QUALITY ASSURANCE -- NON-CONFORMANCE REPORT

Report No: NCR-000394

Component: Segment Splice Weld Joint 1AAE/1AE at LD

Job Name: SAS Superstructure

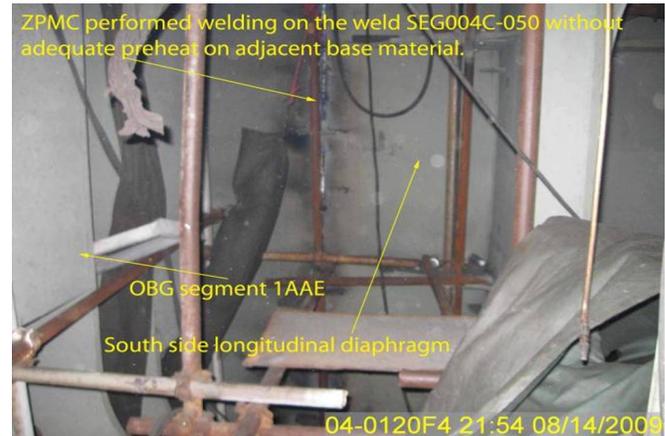
During the random visual inspection this Caltrans Quality Assurance Inspector (QA) observed ZPMC personnel performing Flux Core Arc Welding (FCAW) on the weld SEG004C-050, south side longitudinal diaphragm transverse segment splice weld joint of 1AAE to 1AE, without adequate preheating of the adjacent base material. This QA Inspector observed a 65 degree Celsius Tempstick did not melt when applied to the adjacent base material.

Welding Procedure Specification WPS-B-T-2233-B-U3-F, minimum preheat temperature required is 65 degree Celsius.

Submit repair plan for the engineer's approval.

ABF performed the required NDT for the weld in question. NDT reports show that the weld is in conformance with the Contract requirements.

Component: Segment Splice Weld Joint 1AAE/1AE at LD

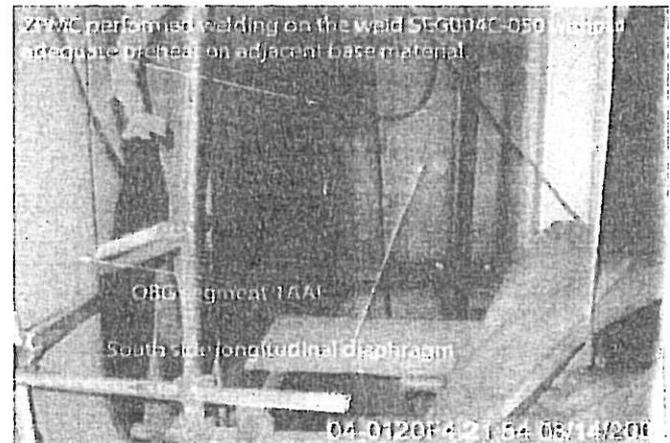
During the random visual inspection this Caltrans Quality Assurance Inspector (QA) observed ZPMC personnel performing Flux Core Arc Welding (FCAW) on the weld SEG004C-050, south side longitudinal diaphragm transverse segment splice weld joint of 1AAE to 1AE, without adequate preheating of the adjacent base material. This QA Inspector observed a 65 degree Celsius Tempstick did not melt when applied to the adjacent base material.

Welding Procedure Specification WPS-B-T-2233-B-U3-F, minimum preheat temperature required is 65 degree Celsius.
